Access Compliance Report

Public Rights-of-Way

(Curb Ramps)

Intersection ID: 28004	Main Street: BLACK_WATCH_CT	Cross Street: WILLOW_ROCK_DR	Location: NE
ADA ID: A146BAC0A947	Ramp Type: ParaDiag	Initial Pass/Fail: Fail	Overall Compliance: No
		Severity Score: 25

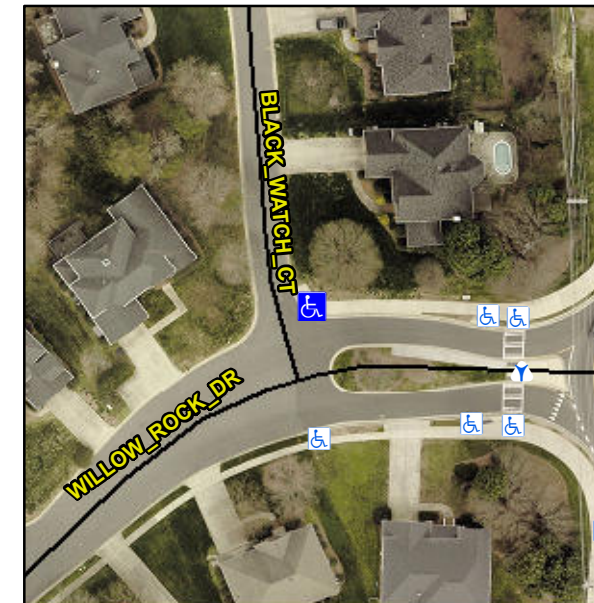
LT RP < 5%

R304.3.2

Remove & Replace Curb Ramp With Two New Directional Ramps or Equivalent.
